WAITOMOKIA ESTATE PLAN CHANGE – TRANSPORT CLAUSE 23 RESPONSES

Flow Transportation Specialists Limited (Flow) has prepared this letter responding to the transport-related Clause 23 Requests for Further Information (RFI) received from Auckland Council (Council) on the proposed Waitomokia Estate Plan Change in Mangere, Auckland (the Site).

Figure 1: Montgomerie Road / Pavilion Drive intersection Traffic Counts

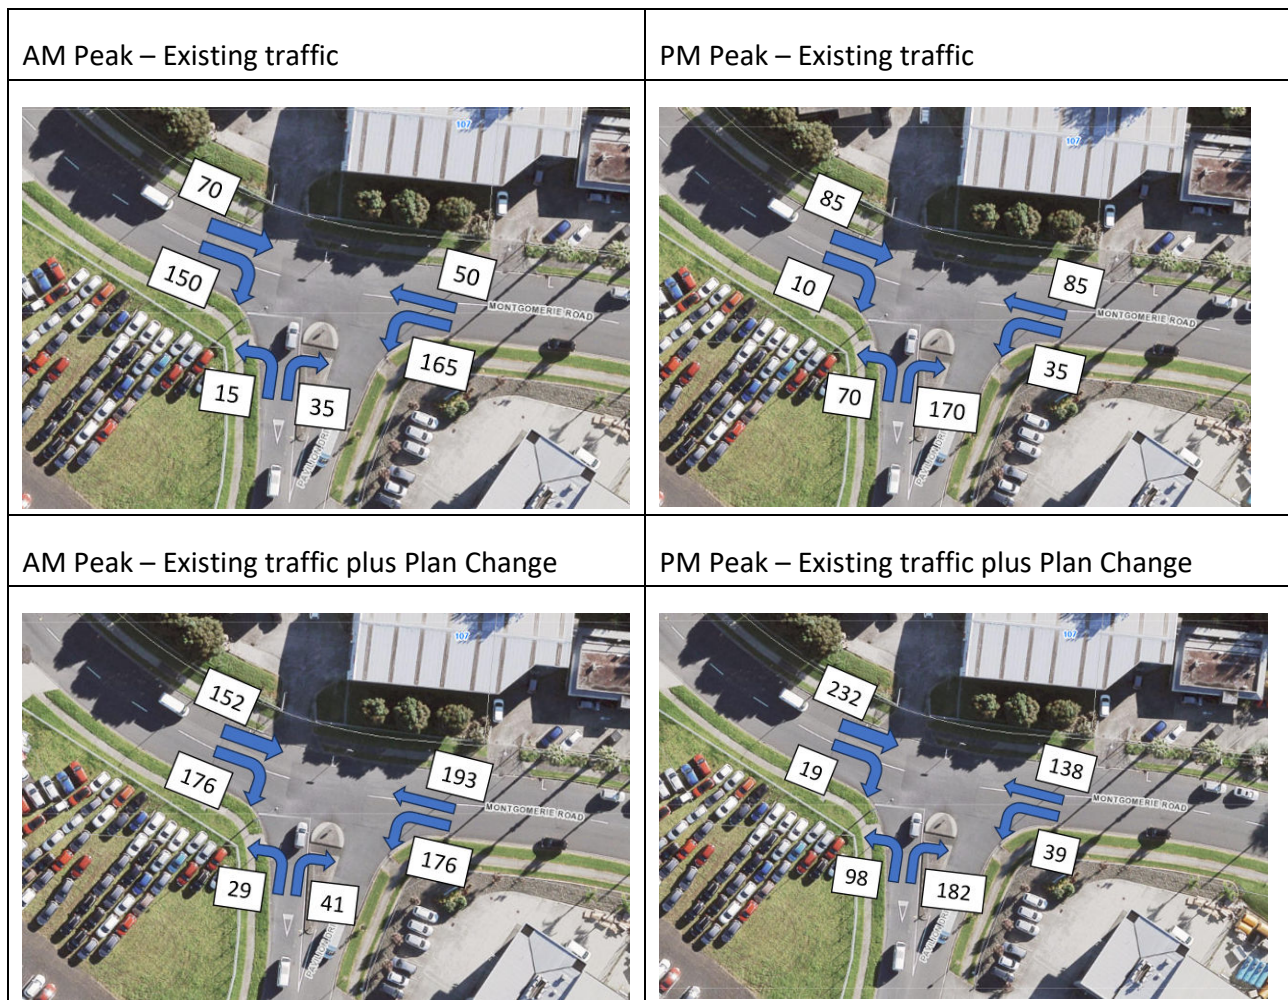
Please confirm traffic distribution assumptions and undertake a capacity assessment of the priority Pavilion Drive/ Montgomerie Road intersection for inclusion in the ITA.

We haven't specifically surveyed the Montgomerie Road / Pavilion Drive intersection, however, we have surveyed both the upstream and downstream intersections on Montgomerie Road as set out in Section 3.5 of our ITA. We have estimated the turning volumes in and out of Pavilion Drive on the basis that the traffic flows on Montgomerie Road are 'balanced'. Our calculated traffic volumes at the Montgomerie Road / Pavilion Drive intersection are summarised in Figure 1 below and include the morning and evening peak periods, without and with the plan change area traffic generation.

The same trip distribution as outlined in our ITA has been used, namely:

- ◆ A 70 % trip distribution to/ from Ascot Road (to the north)
- ◆ A 30 % trip distribution to/ from Richard Pearse Drive (to the south).

We have assessed the performance of the Montgomerie Road / Pavilion Drive intersection using Sidra, and can conclude that the capacity of the intersection remains acceptable with and without the plan change area traffic generation. The Sidra results are included in Appendix B.

Figure 2: Sight line assessment for the existing Pavilion Drive access - right turn-in movements

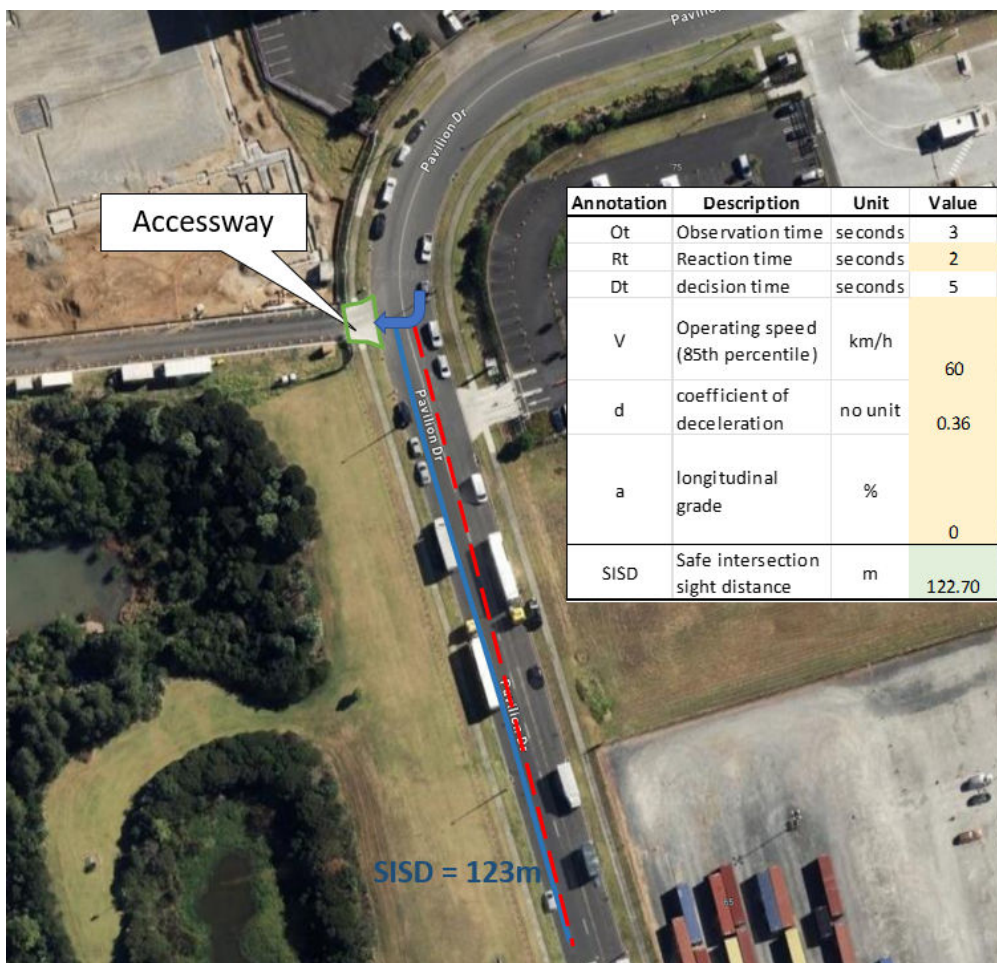
- confirmation that they will not facilitate through access to Montgomerie Road, otherwise specify mitigation measures to enforce their function of only facilitating local access;*
- in relation to intersections with Pavilion Drive, mitigation measures to enforce the 'no right turn outbound' access arrangements, with consideration of a similar 'no right-turn inbound'.*
- restriction also being recommended as a mitigation measure for ensuring safe vehicle movements on-site from Pavilion Drive as development progresses within the proposed precinct; and*
- assess traffic effects of proposed left-in/left-out arrangement on traffic distribution analysis (cross-reference with further information item 7(a)(ii) above).*

Even though specific accessway conditions like the restrictions recommended by Auckland Transport are considered a design matter that could be dealt with at the resource consent stage, we consider that there is no need to restrict vehicle movements at the Pavilion Drive accessway, as sufficient sight lines exist as illustrated in Figure 2 and Figure 3. Although the existing accessway already operates with an outbound left turn-only arrow, we have considered sight lines towards the southeast of the accessway as well.

Furthermore, SISD of about 120 m (with an operational speed of up to 60 km/hr) exists towards the north for drivers wanting to turn right into the accessway from Pavilion Drive.

Appendix C: Montgomerie Road access concept design example

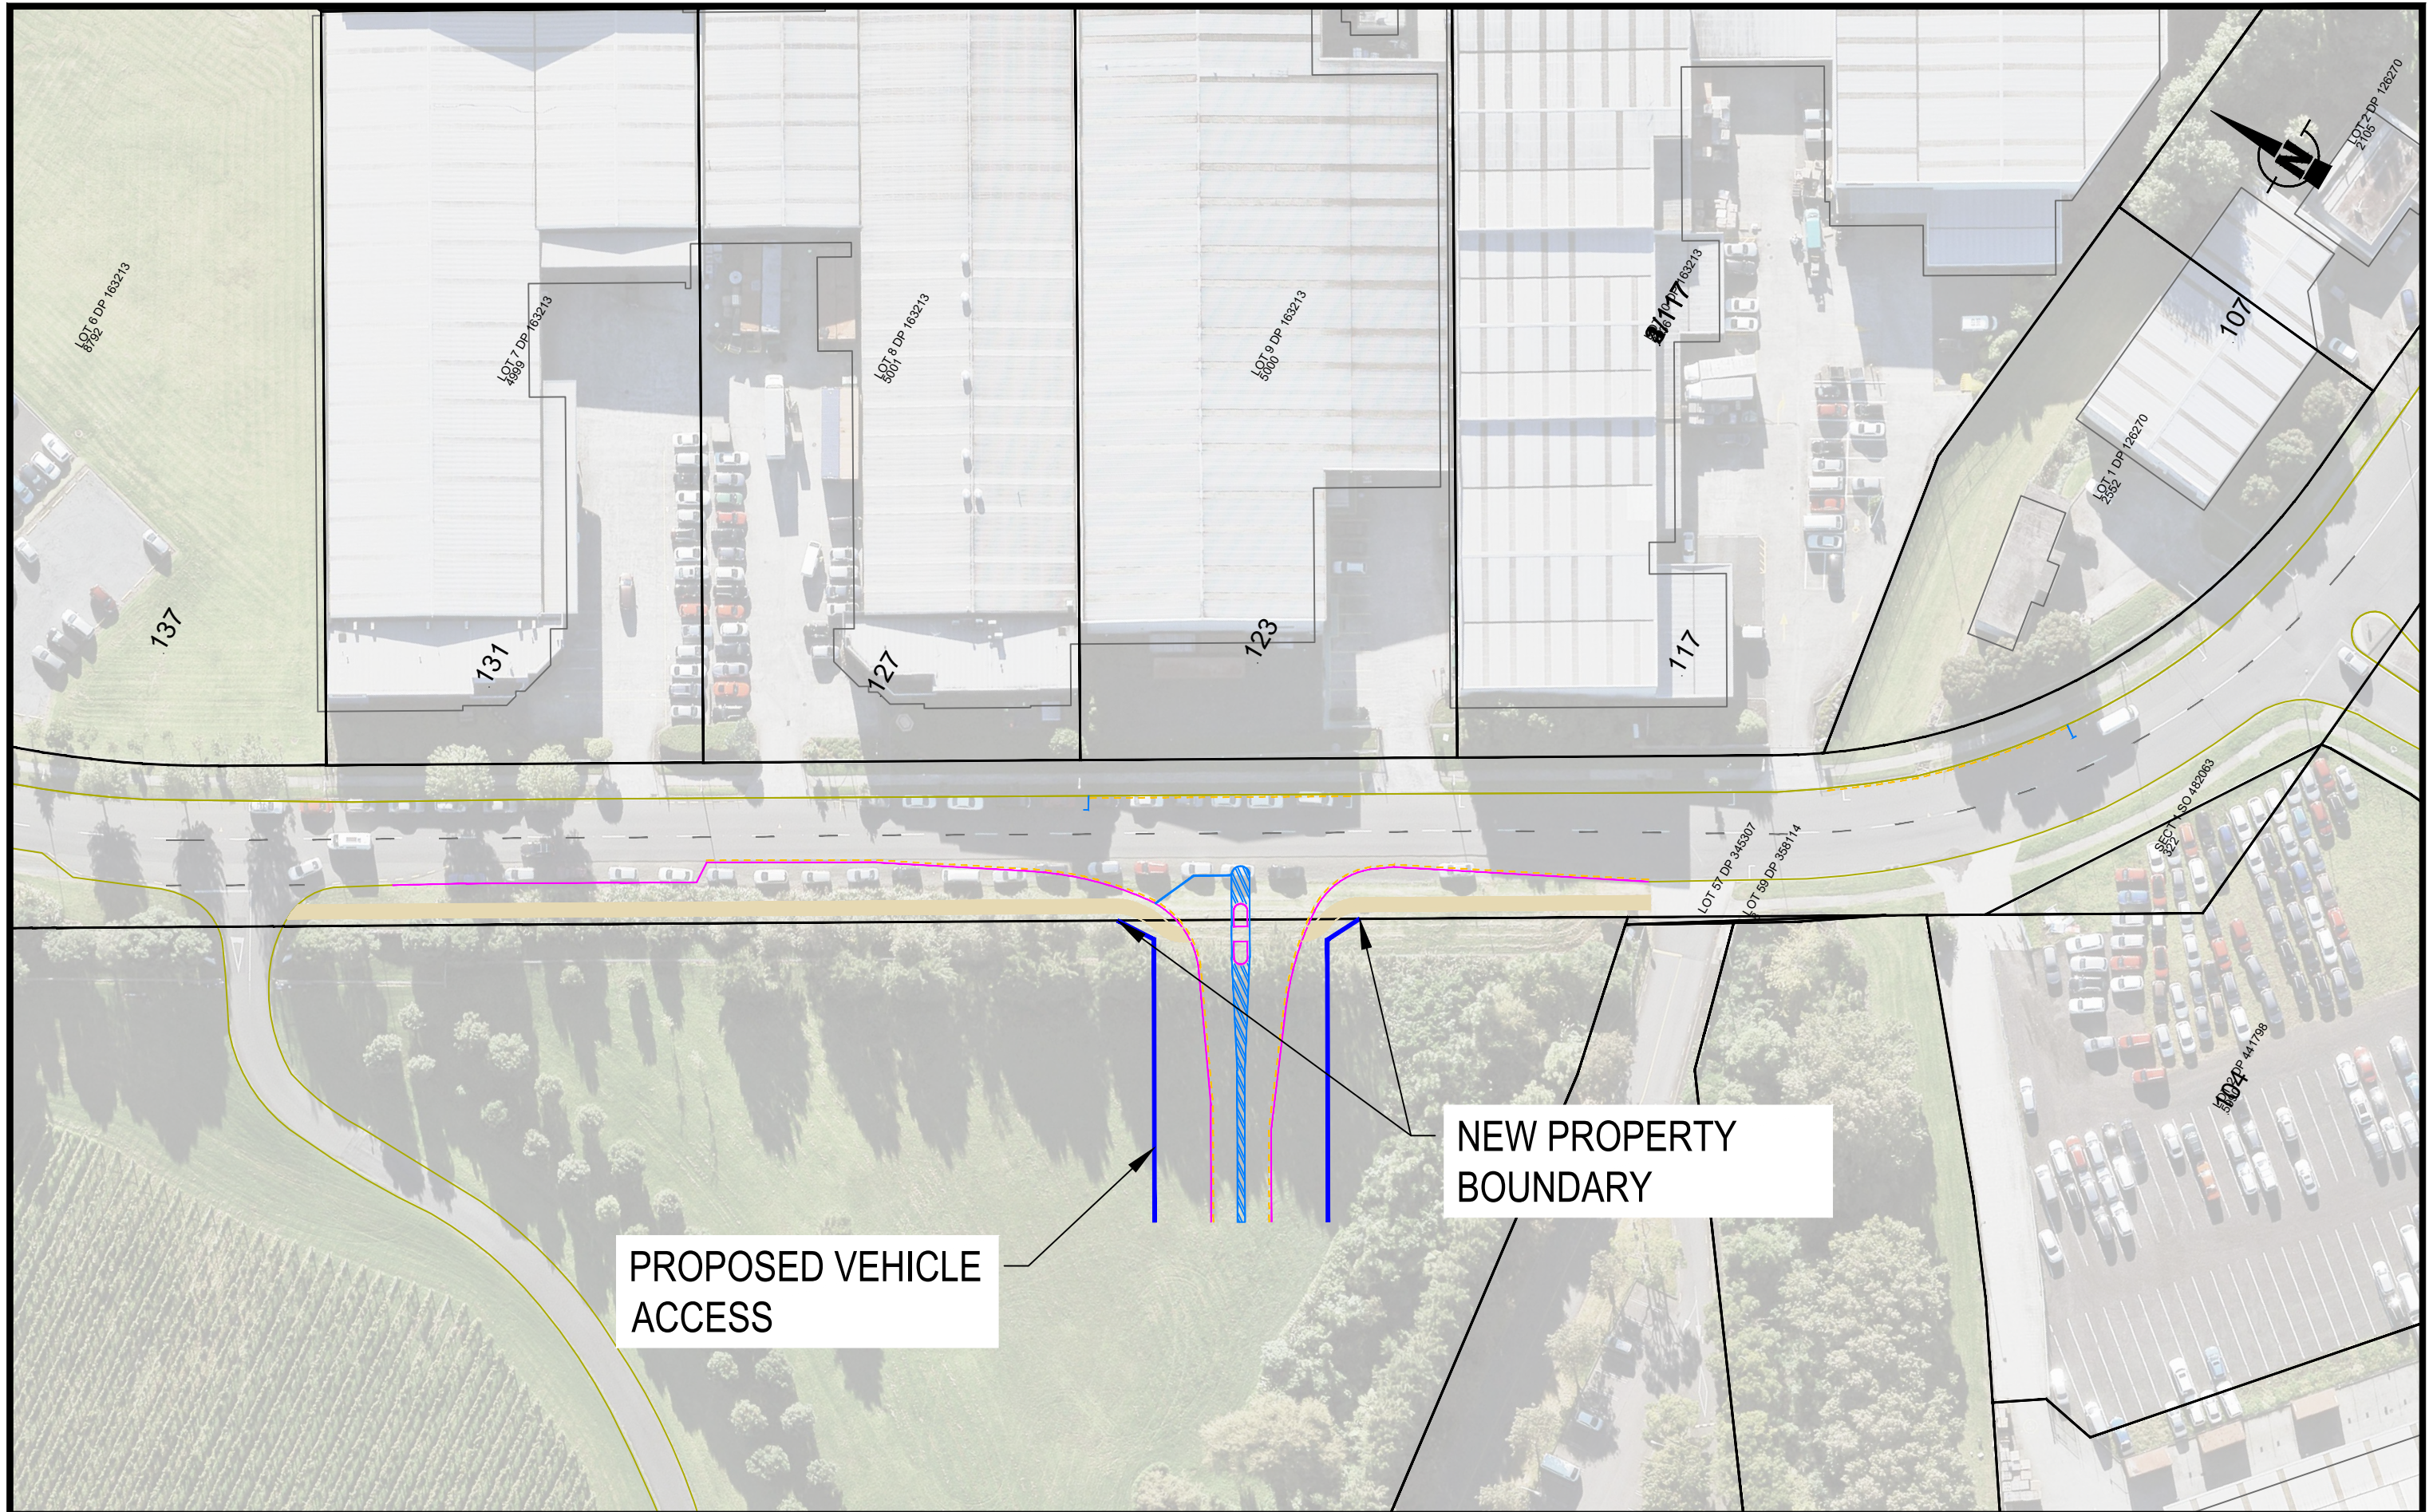
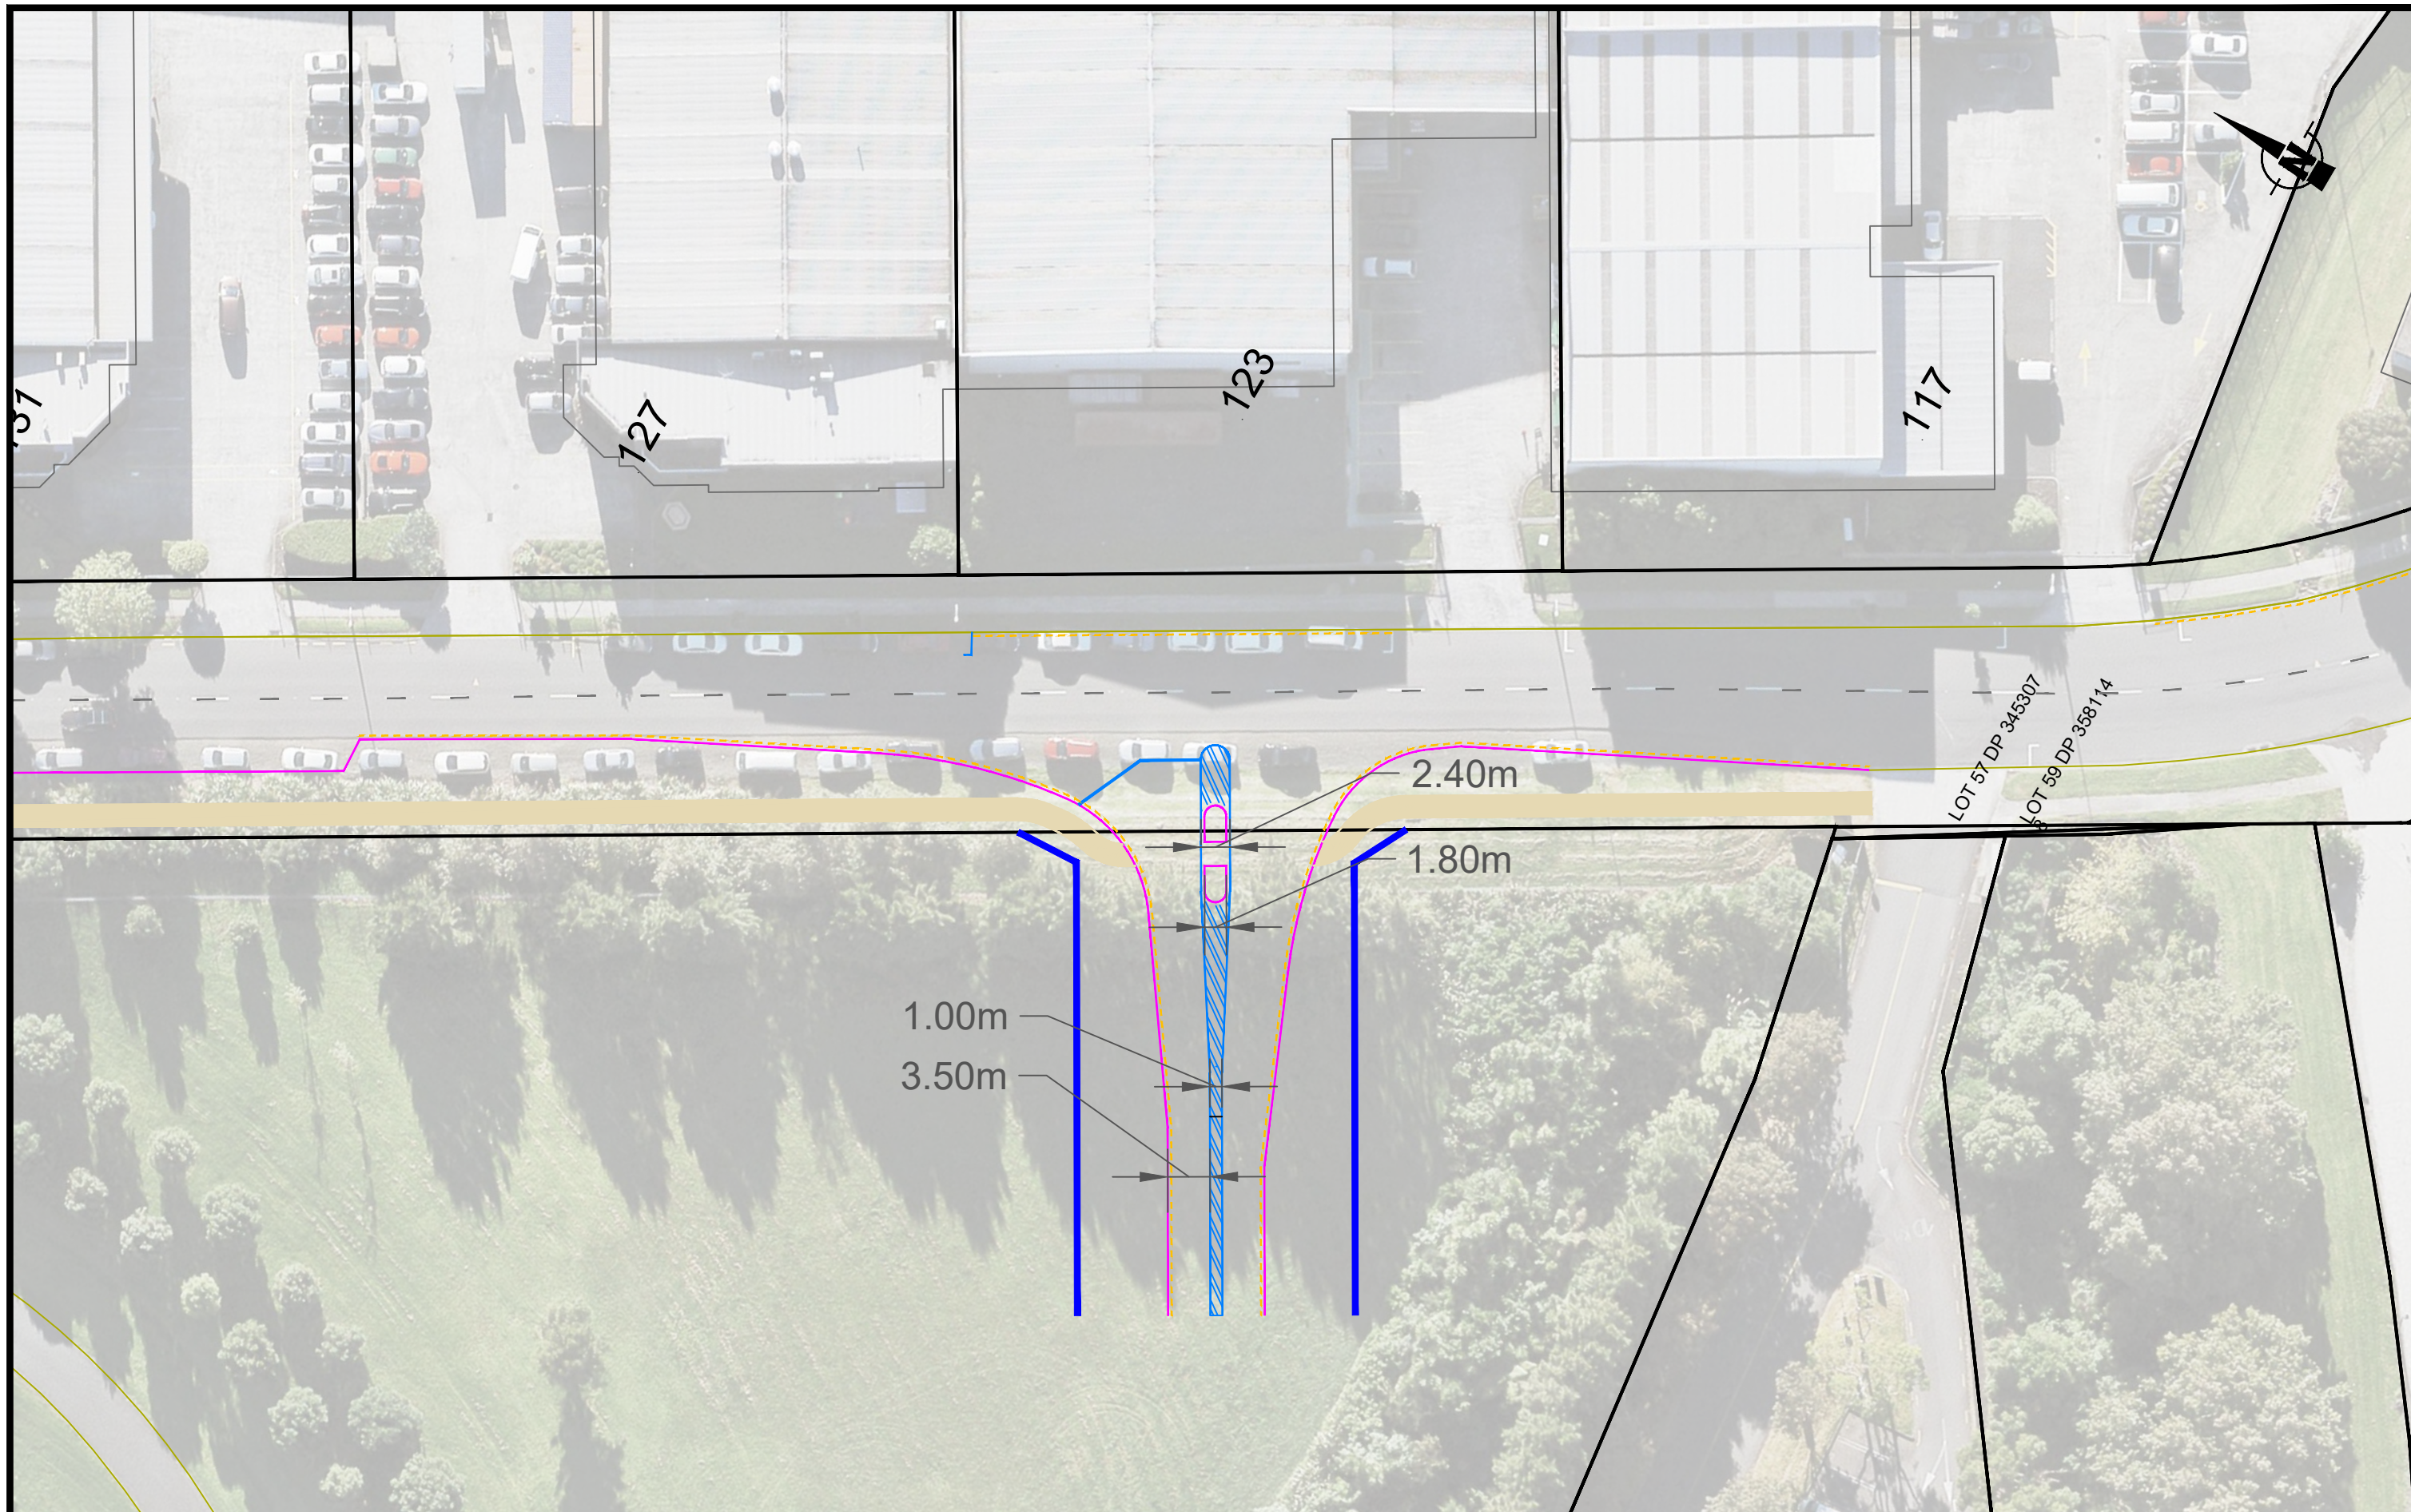
- *anticipated urban transport functions, including access for freight, public transport and pedestrians and active mode users (including provision of pedestrian and cycle facilities to the Oruarangi Rd/Ascot Rd roundabout intersection along the proposed urban road frontage), with any potential access for public transport being subject to engagement with Auckland Transport;*

- *key principles to inform it's likely future urban form and cross-section design, based on identified transport functions (e.g. provisions for on-street parking, public transport infrastructure if applicable, provisions for active mode users etc.) and how the proposed precinct provisions will incorporate these principles, particularly in relation to being designed for a low speed environment; and*

- *assessment of key principles for future intersection with Montgomerie Road, including an assessment of visibility, separation from any existing vehicle crossings or intersections, and potential for alternative intersection forms based on outcomes from any updated trip generation assessments provided in response to further information item 7(a)(i) above.*

We have prepared a concept design of the Montgomerie Road access, attached as Appendix C. The concept design identifies the appropriate location for access, pedestrian provision requirements across the access road in the form of a refuge island, like the one at the Pavilion Drive intersection, the extent of kerbs required and where parking restrictions are required to enable the required sight lines at the newly formed intersection. We emphasise that this is a concept design and detailed elements will be confirmed and designed at subsequent resource consent stages. The concept design purely outlines the location that enables sufficient sight lines with an indication of how pedestrian and parking provisions along Montgomerie Road may look.

We consider a stop-controlled T-shaped intersection to be the most appropriate intersection form that will facilitate heavy vehicle movements in and out of the plan change area. The stop-controlled intersection could operate with sufficient capacity as outlined in our ITA, with appropriate sight line provisions in both directions for a design speed of 60km/hr (10 km/hr above the posted speed limit). The provision of kerb and channel on the western side of Montgomerie Road will further contribute to reflecting the urban nature of the road and a calmer traffic environment. Given the industrial nature of the area, vertical traffic calming devices are not recommended.

As outlined in the concept design safe intersection sight distances (SISD) of 138 m to the north and 133 m to the south are achieved along Montgomerie Road, reflecting sufficient SISD for an operating speed of 50 km/hr (design speed of 60 km/hr and consideration of vertical alignment).
